February 17, 2017

Project IR15165930

**Re: Comments on the 2016 Final Remedial Investigation Report
Former Marchant/Whitney (FMW) Site
5679 Horton Street, Emeryville, California**

Figure 9
Sub-Slab Soil Vapor Results
 5679 Horton Street, Emeryville, California

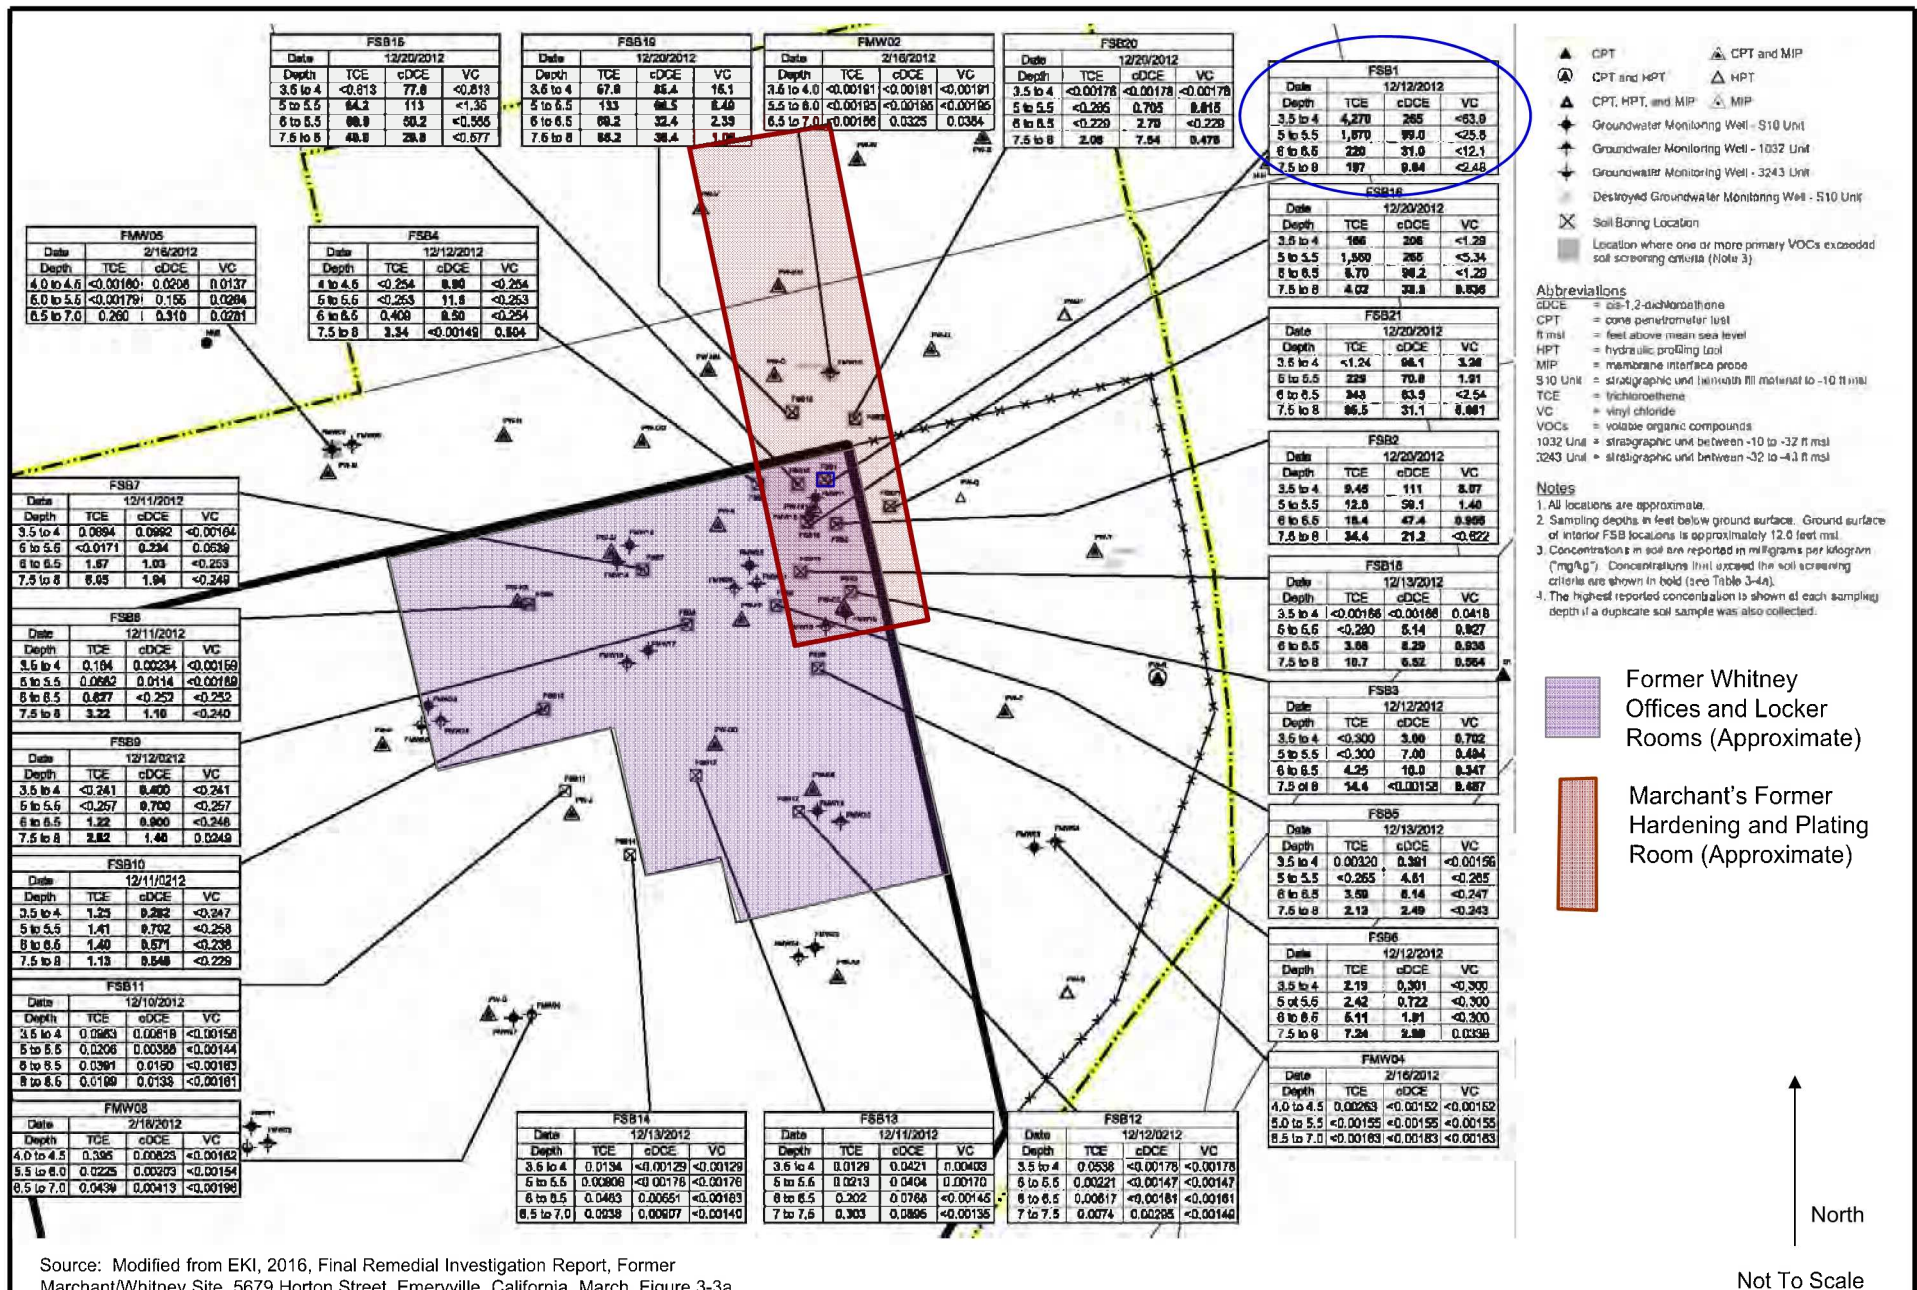
TCE concentrations in the sub-slab vapor samples in the Northwestern Area (Figure 9) ranged from 659 to 6,600 $\mu\text{g}/\text{m}^3$. These concentrations are one to two orders of magnitude lower than the concentrations observed in the Northeastern Area (4,420 to 26,500 $\mu\text{g}/\text{m}^3$). The detection of TCE in sub-slab vapor in this area may be attributed to lateral vapor movement from the Northeastern Area in the zone between the Current Building’s slab and the old slab. The potential for movement and connection of VOCs in sub-slab vapor were acknowledged by EKI (2012, page 6-6), where EKI states, “[t]he sub-slab vapor may be more laterally connected than deeper soil vapor due to the more permeable material that is typically used as a base for foundation construction. Therefore, it would not be surprising to see more disperse VOCs in the sub-slab vapor than in the soil vapor.”

PCE was detected in the sub-slab vapor samples (68.2 to 540 $\mu\text{g}/\text{m}^3$) in the Southern Area (Figure 9). The presence of PCE in the Southern Area may be the result of migration from the Northeastern Area, where PCE may have been present in sub-slab vapor samples but was not detected. The presence of the PCE may have been masked due to the elevated detection limits¹⁶ resulting from the very high concentrations of TCE; the PCE in both locations therefore could be associated with Marchant's operations.

The third floor drain is located near the east wall just south of the Current Building's office area (Figure 9). Sub-slab vapor samples collected about 40 feet north (SSV12) and 40 feet west (SSV10) of this floor drain had TCE concentrations of 21,500 and 7,560 $\mu\text{g}/\text{m}^3$, respectively. The sub-slab vapor concentrations in this area are likely attributed to the higher sub-slab vapor concentrations observed in the Northeastern Area and lateral movement of vapor through the permeable fill material associated with the sub-slab soil.

PLOT PLAN
SCALE 1" = 20'

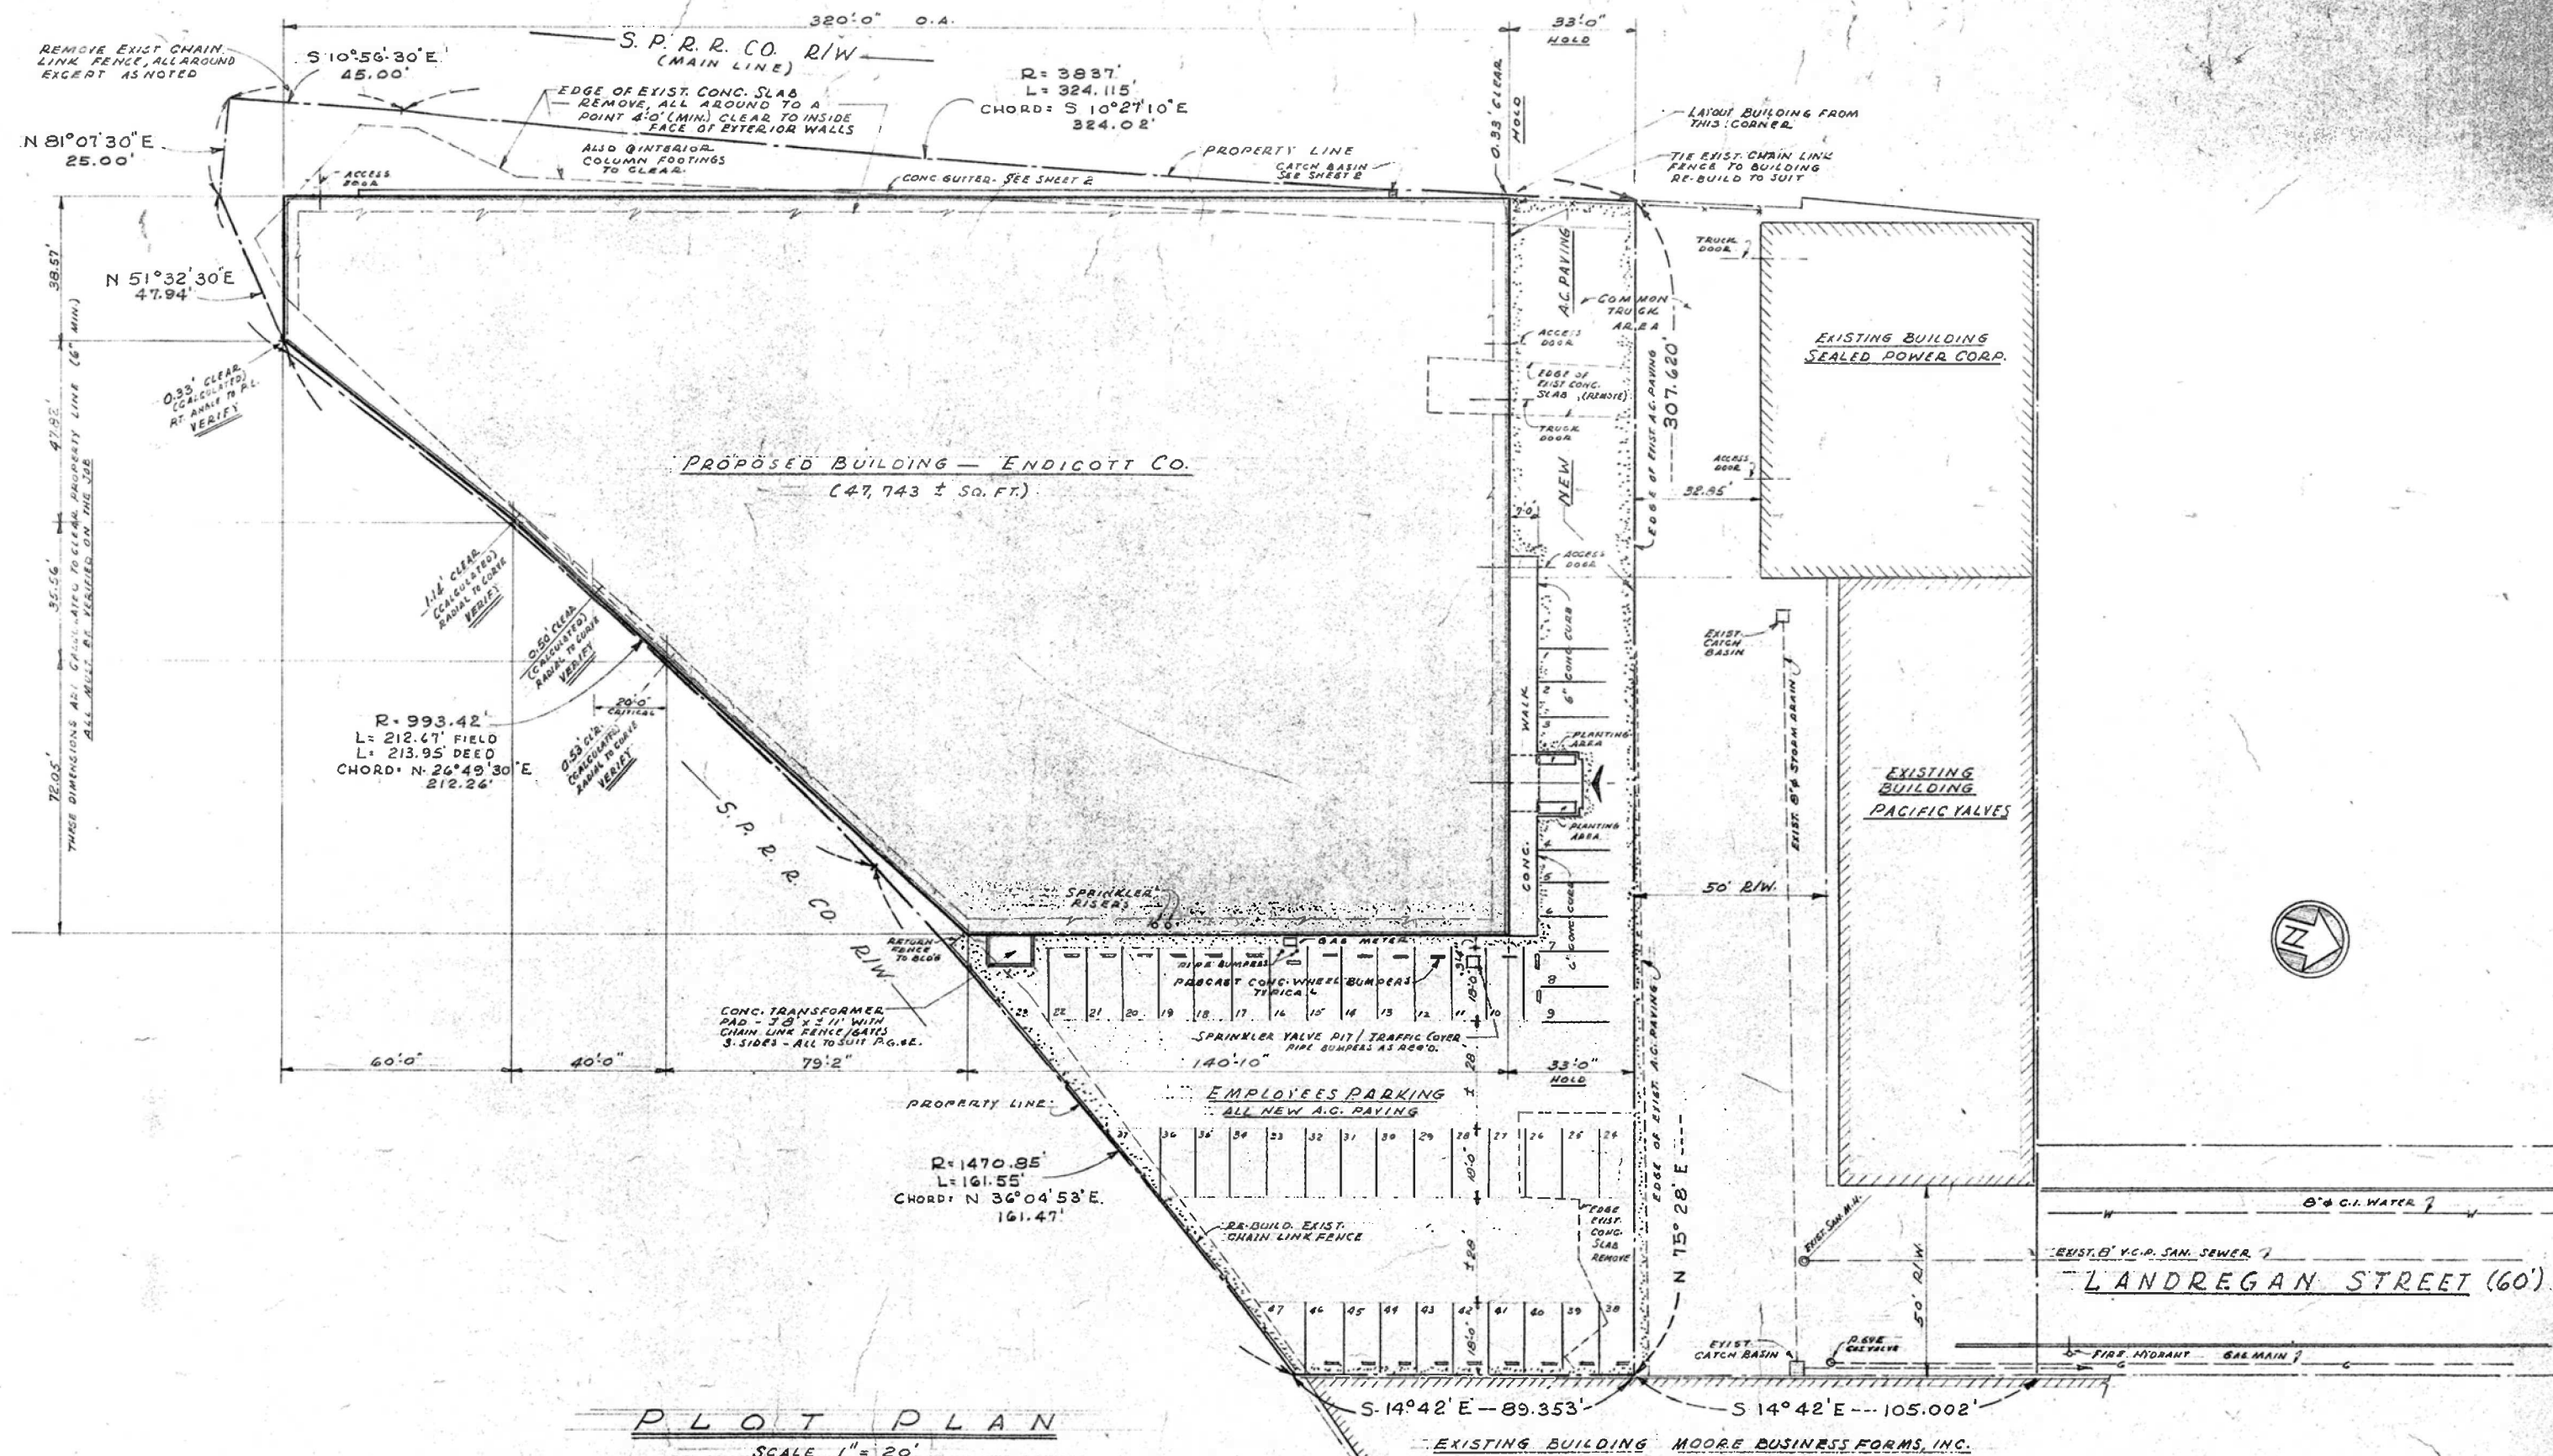
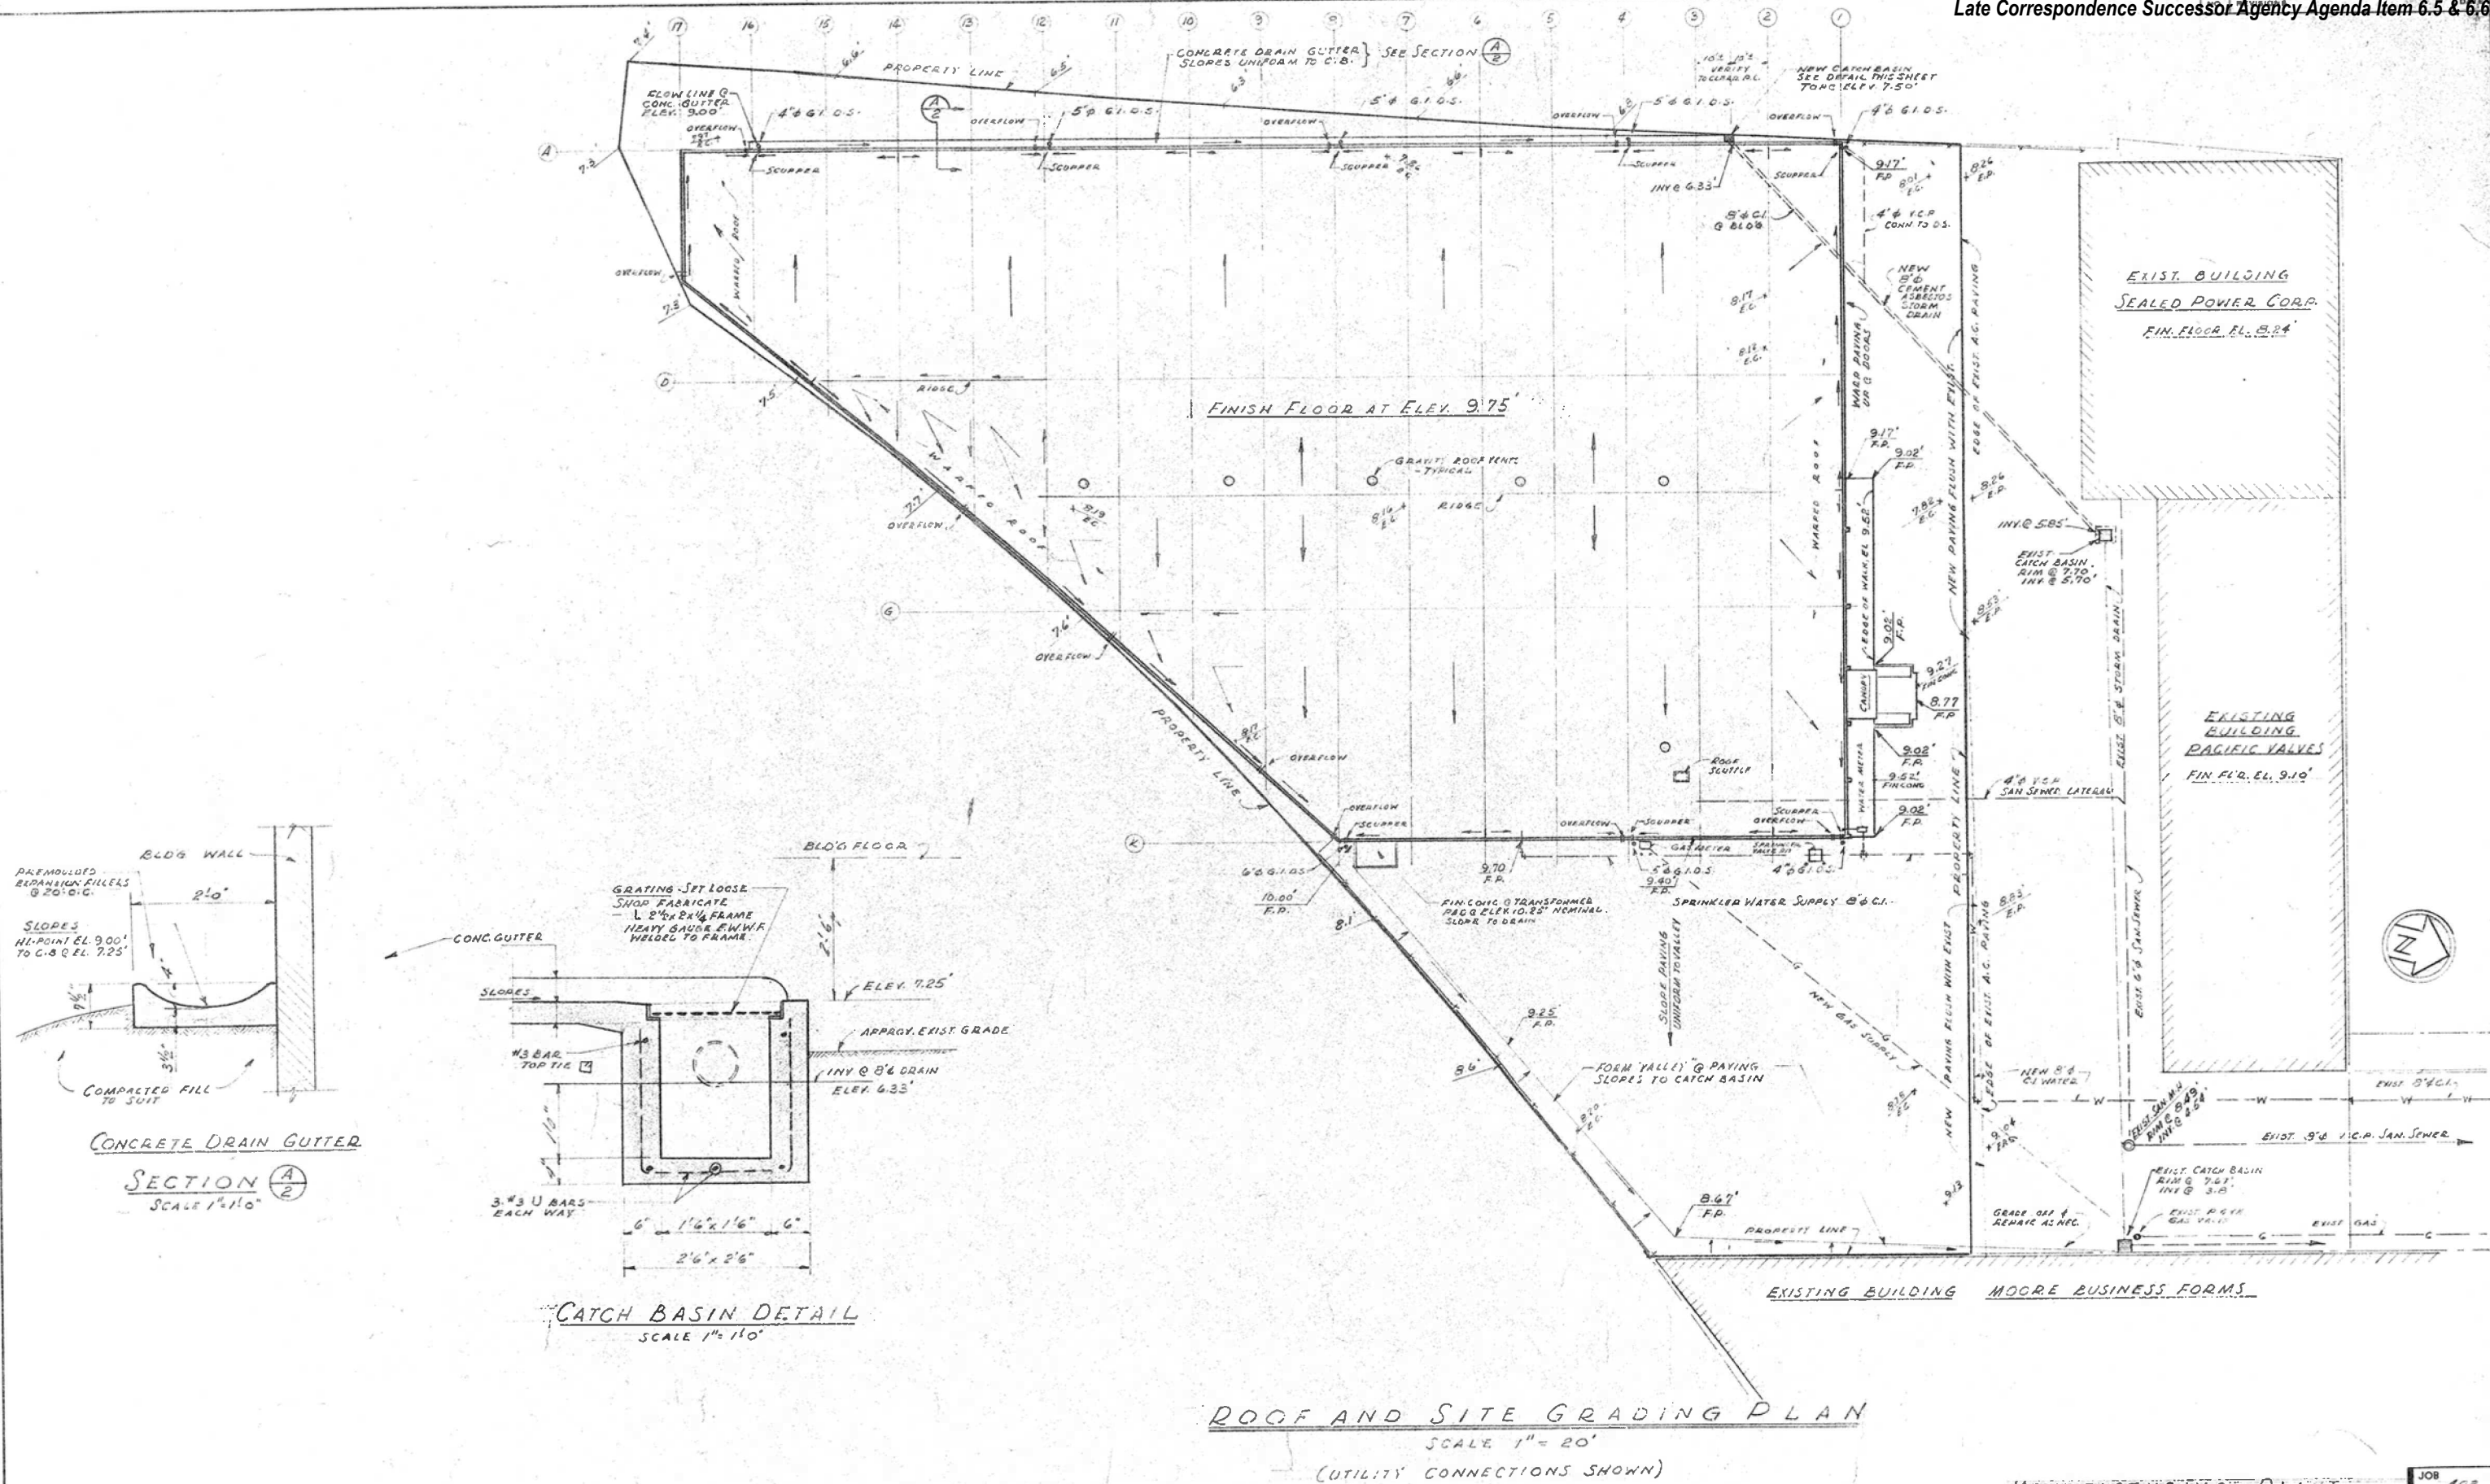
EKI encountered the old slab at depths ranging from 0.5 foot to 2 feet below grade (EKI, 2012, page 2-1, Section 2.1 and EKI, 2016a, page 2-4, Section 2.2.2). As seen on the 1963 as-built titled "Plot Plan" (Attachment 2), the old slab remains in place beyond the footprint of the Current Building to the north and east, and its presence was observed by EKI at nine soil vapor sample locations in the parking area around the northeast corner of the Current Building (EKI, 2016, Table 3-6). Up to 2 feet of fill material was placed above the old slab, and a new concrete floor slab was constructed on the fill material during construction of the Current Building. The fill material observed above the old slab reportedly consisted of coarse sand and gravel and backfill material (EKI, 2012, page 4-1). EKI (2012) also indicated that fill was observed below the old slab to a depth of 3 to 5 feet and consisted of silt, sand, and gravel fill (containing concrete and some other debris). As discussed below, the presence of the old slab beneath and outside the footprint of the Current Building is important to understanding the chemical releases at the FMW site.

The main sewer line identified in the 1963 as-built titled "Roof and Site Grading Plan" may also be the original sewer line for the Marchant Facility, given its location running east-west to Horton Street and its depiction on the 1963 as-built titled "Roof and Site Grading Plan" as an "existing sewer line." EKI has not provided information sufficient to conclude that there are any sources associated with the sewer lateral. It is possible that the sewer lateral servicing the Current Building may overlap the original sewer lateral or sewer line for the Marchant Facility. It is also possible that the buildings just north that were once occupied by Marchant (carpentry and machine shop, paint storage, welding room, and maintenance department) and later by another valve manufacturer were also connected to the main sewer line. Based on the operations
